164-170 Croatia Ave, Edmondson Park SSWPP Review Panel RFI Landscape & Public Domain Responses

By: Site Image Landscape Architects

Date : 30 June 2021

SSWPP Review Panel Requests for Information (26 April 2021) -Landscape & Public Domain Responses

Precinct Plan

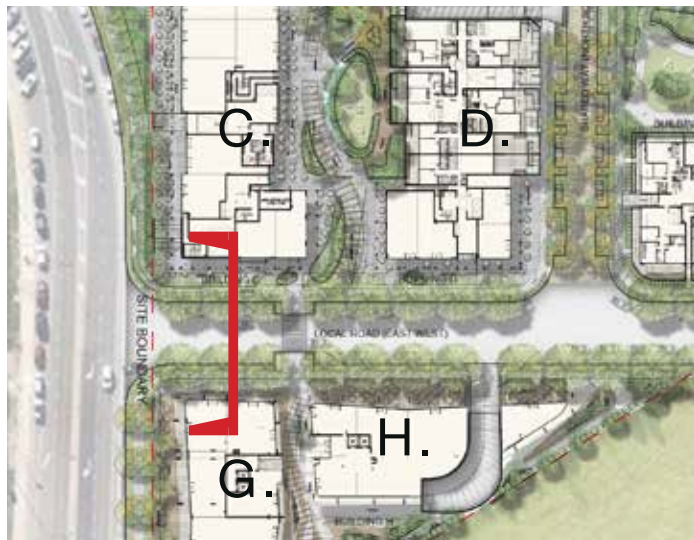
- clarification of building front setbacks and undercroft retail setbacks, and building changes to suit;

Architectural sections demonstrate setbacks in response to RFI. In support, landscape sections demonstrate streetscape and public domain relationship, including street trees, lawn edge, footpaths, and defined seating areas. Variety of detailing to define retail seating areas will provide identity to separate tenancies, and create diversity within a managed retail format that provides overall consistency of presentation, signage, weather-proofing panels, and common area edge condition.

Retail seating areas defined by paving material change, permanent and temporary ID barriers, level change, and landscape treatments

Road crossing marked by unit paving to distinguish pedestrian / shareway. Formal crossing subject to approval.

Street trees in structural soil trench behind kerbline, with lawn / groundcover / paving finishes to suit specific locations

Broad terrace with planter / landscape to footpath edge, with landscape flanking entry points to defined retail seating areas. Activation of streetscap the key outcome.

Precinct Plan

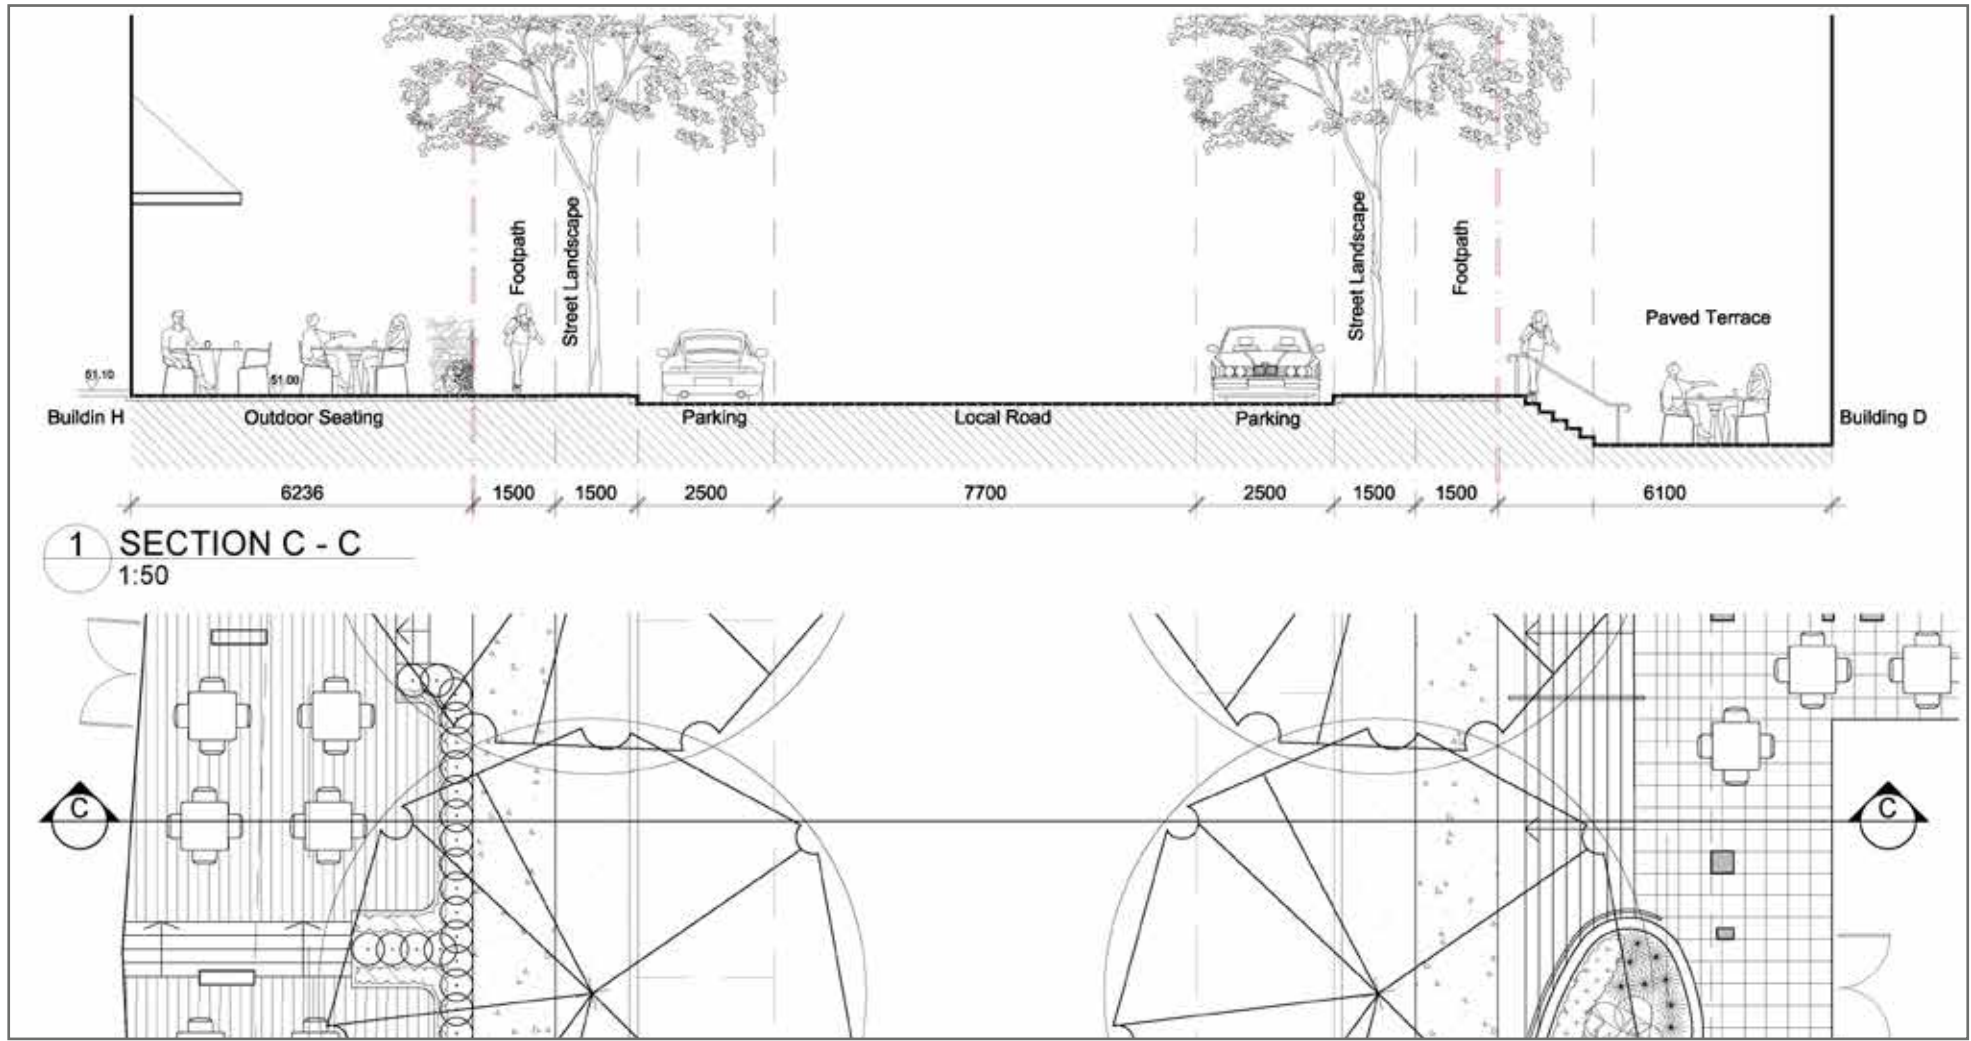
- clarification of building front setbacks and undercroft retail setbacks, and building changes to suit;

Transition of street levels along frontages result in some level changes managed with planters and also stairs and ramps where suitable, with slope of street allowing accessible entry point to one end of retail terraces.

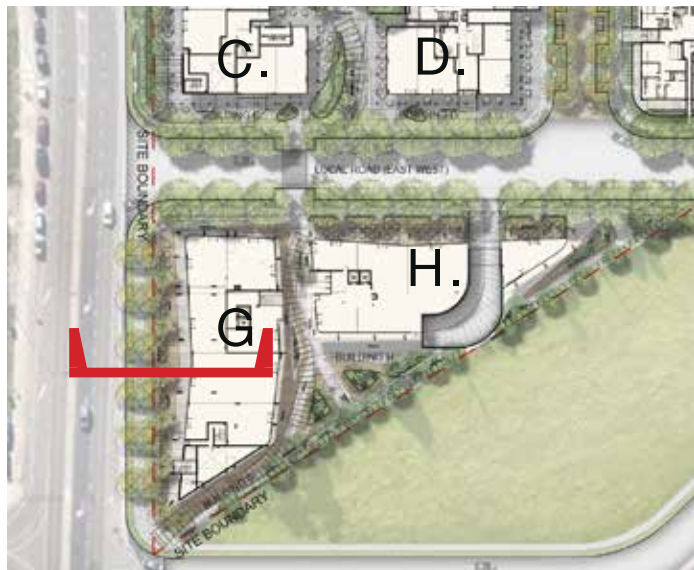
- clarification of building front setbacks and undercroft retail setbacks, and building changes to suit;

The Building C relationship with Soldiers Parade is generally level, again with the sloping street requiring some transition steps at each end, with retail access from the terrace where level with the street.

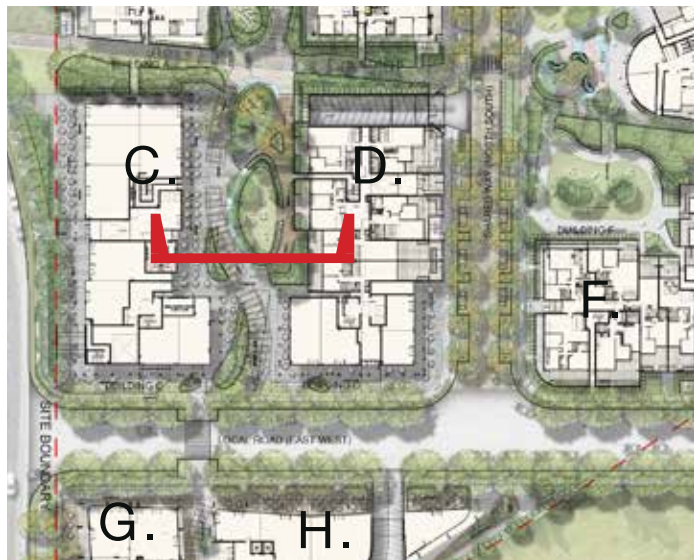
- clarification of building front setbacks and undercroft retail setbacks, and building changes to suit;

This gateway location for the main north-south link has emphasis on greening of edges, with flanking retail. The sloping path corresponds with the falling landform, and moving north the path is level with the strongly engaged retail to the west side.

The Cabbage Tree Palms (*Livistona australis*) and the climber covered canopy reinforce the north-west journey.

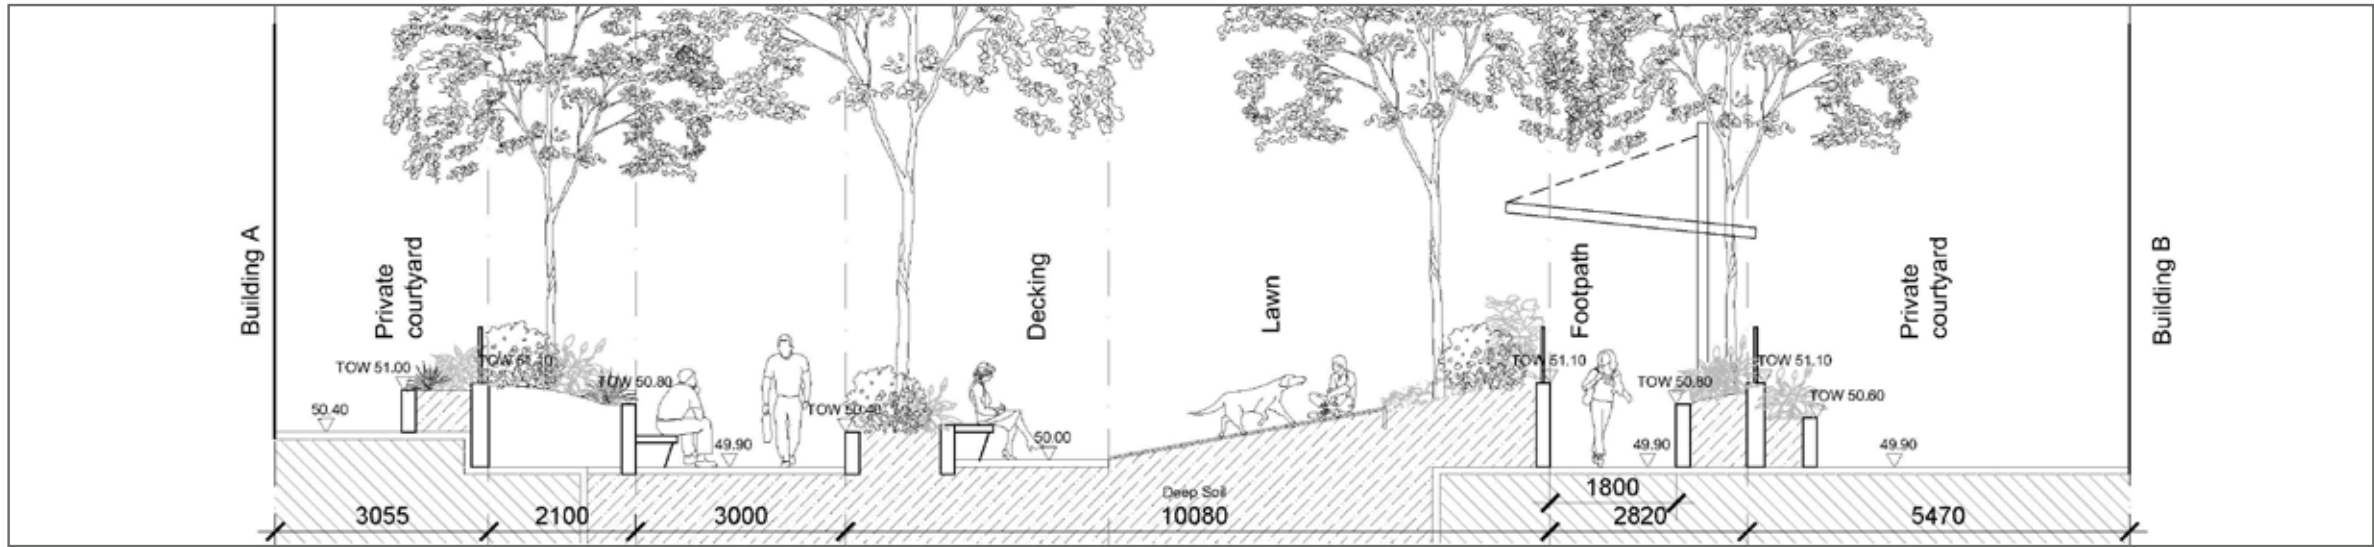
- clarification of building front setbacks and undercroft retail setbacks, and building changes to suit;

The north-south link progresses north to have broader retail seating terraces to the west.

The shareway link continues to be prominently marked by overhead canopy / pergola

The feature glazed upstand on the east edge of the walkway has skylight glazing / public art endemic plant imagery, providing natural light to the basement, and in the evening is backlit as a feature edge to the walkway.

Gated access to the COS to the east accesses the oval shaped sloping lawn, and private walkway with seating edges.

Private residential courtyards are provided privacy with planters greening the level change to create appealing private terraces.

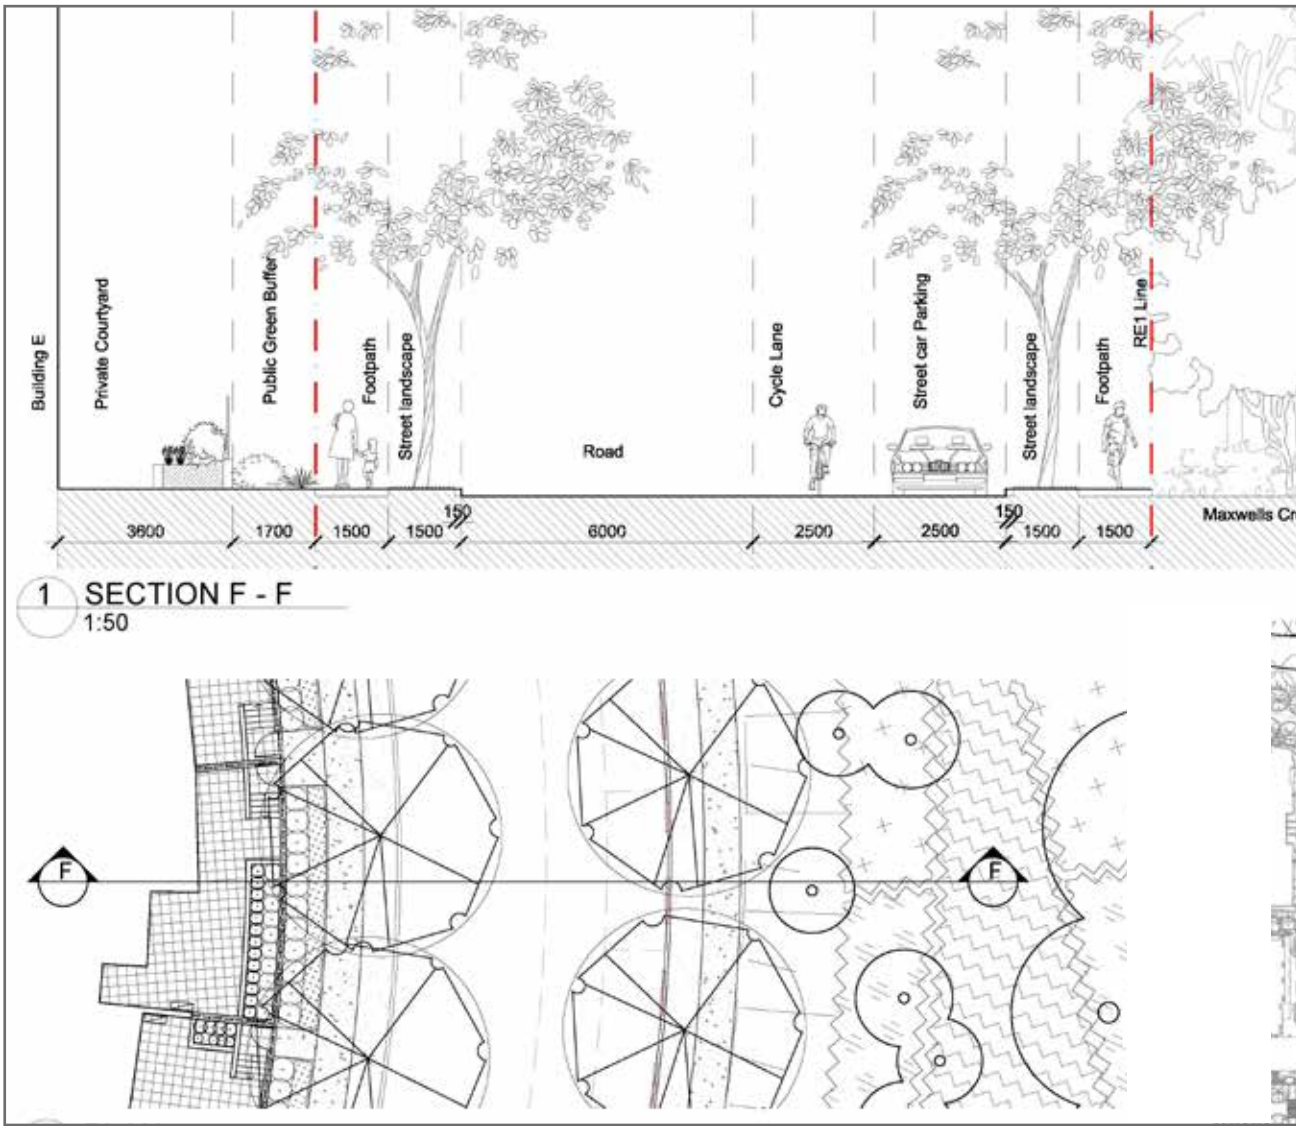
- b) indicate 2.5m off road Cycleways and 1.5m footpath to roads as per DCP
- c) indicate Pram crossings at all intersections as close to Kerb TP as possible and in the centre of the kerb return.

2.5m Cycleways are off-road for shareway cross site link. 2.5m cycleway is on-road for perimeter loop road due to requirement for 8m fire truck access dimension, which precluded swapping.

To suit suitable approval conditions, full details of cycleways and shareways, and associated details of bike parking, end of trip facilities, signage and the like will be provided by a suitably qualified transport consultant.

Red: Pedestrian link; Orange: Shareway; Yellow: Cycleway

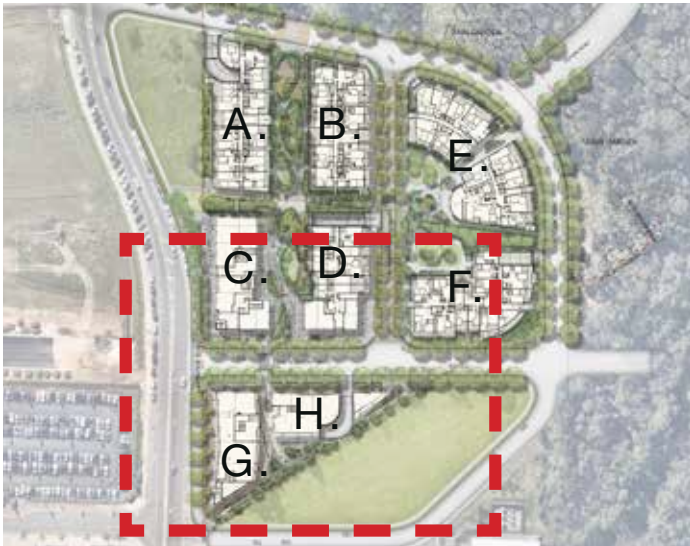
12.1.2 To create linkages to other developments and riparian zones, enabling pedestrian access and connectivity through the site, including to clarify cycling routes;

The north-south riparian link has been reinforced with full pedestrian crossing and raised threshold shown, but understand this is subject to approval. Fallback is to pave this portion of road and provide clear identification of presence of pedestrians with bollards, lights, signage and other treatments such as public art. A new undercroft pedestrian link to the NE has been introduced. The eastern cross site link termination is notionally a paved roadway portion to highlight pedestrians, along with bollards, lighting, laybacks. Further resolution at DD stage can be completed in response to an approval condition. To suit suitable approval conditions, full details of cycleways and shareways, and associated details of bike parking, end of trip facilities, signage and the like will be provided by a suitably qualified transport consultant.

Precinct Plan

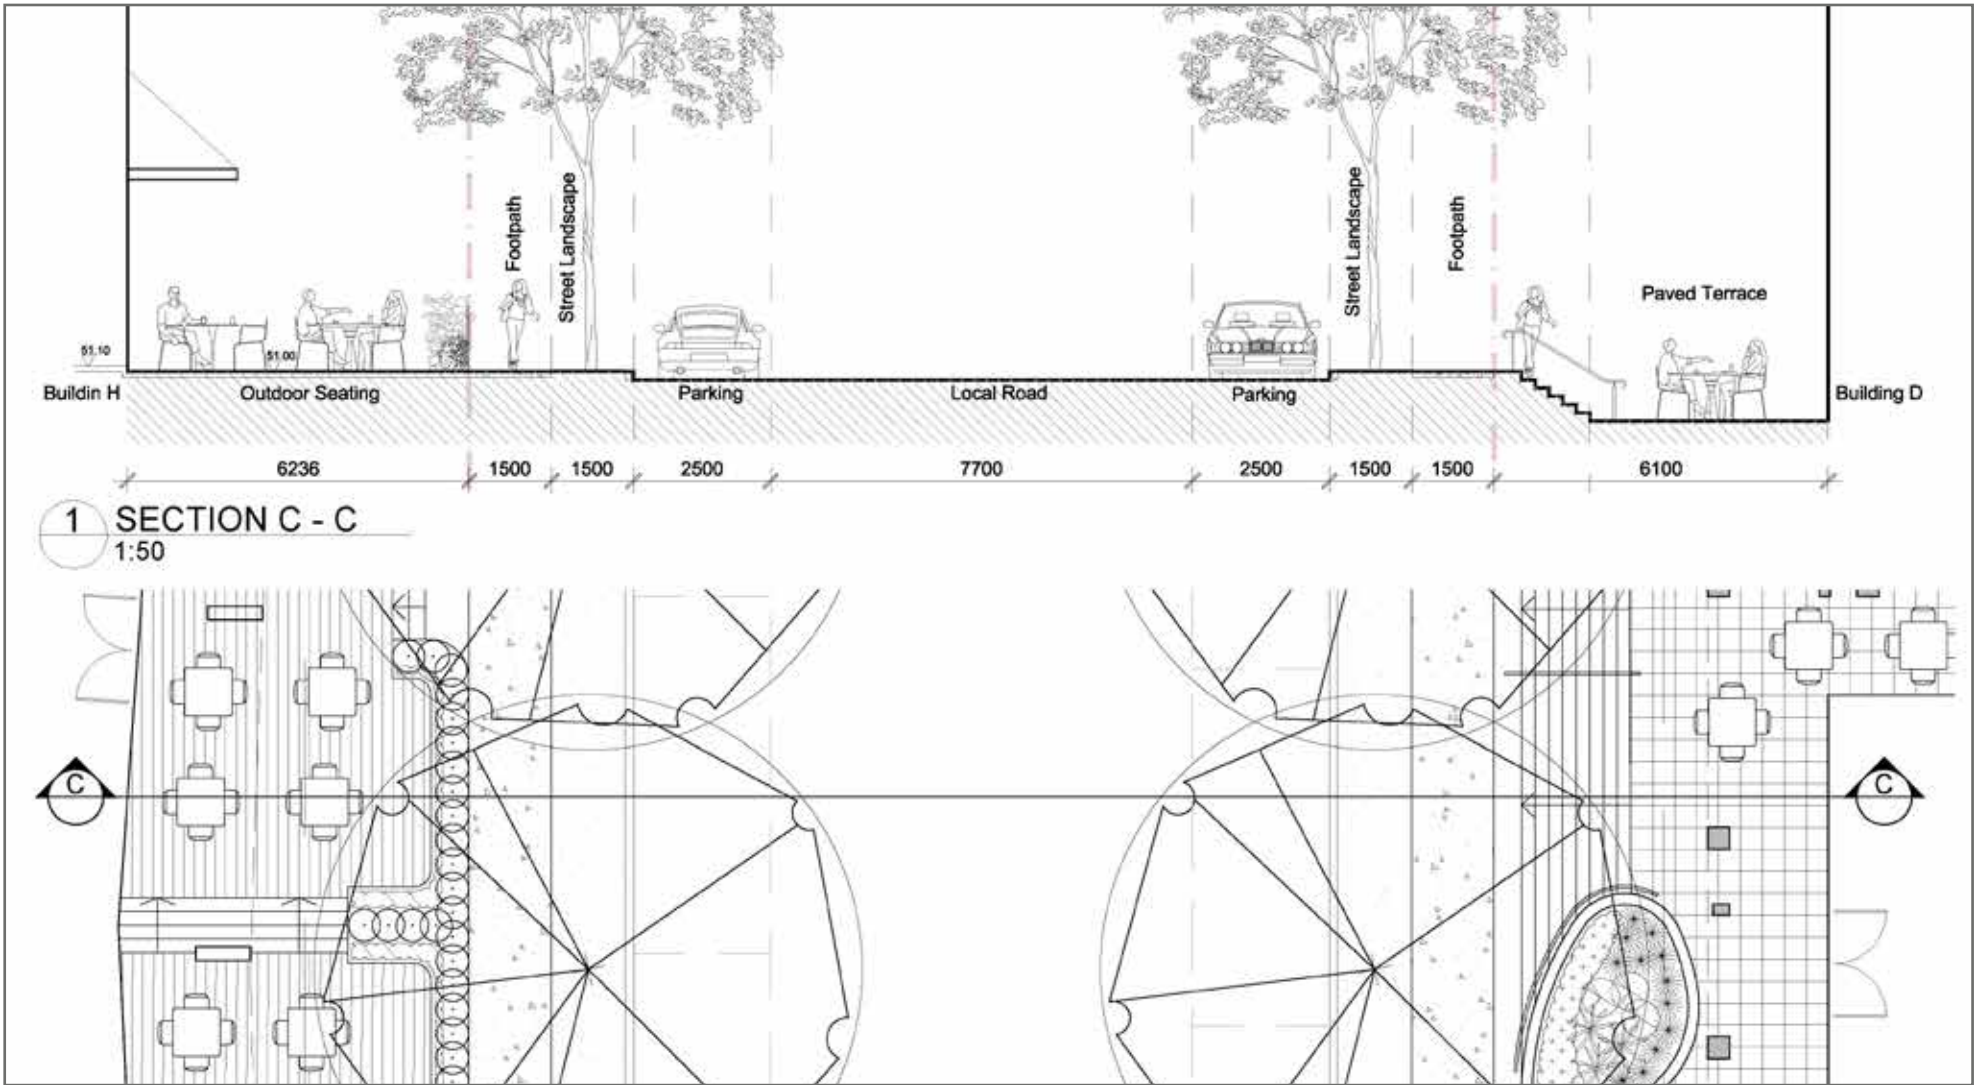
12.5.2 The information provided does not clearly indicate how commercial and retail tenancies will engage with the street. Consideration should be given to visibility and access to these space by the general public. Provide details of public domain/ landscape treatments around the access points and retail frontages within the drawings.

Detailed plans, sections and supportive imagery provided in the responses to '1. Planning Matters' section earlier in this document.

These demonstrate that the proposals reference the existing Ed Square retail outcomes, and enhances these to specifically respond to the strong north-south pedestrian corridor, and to provide activation to street edges in locations as shown.
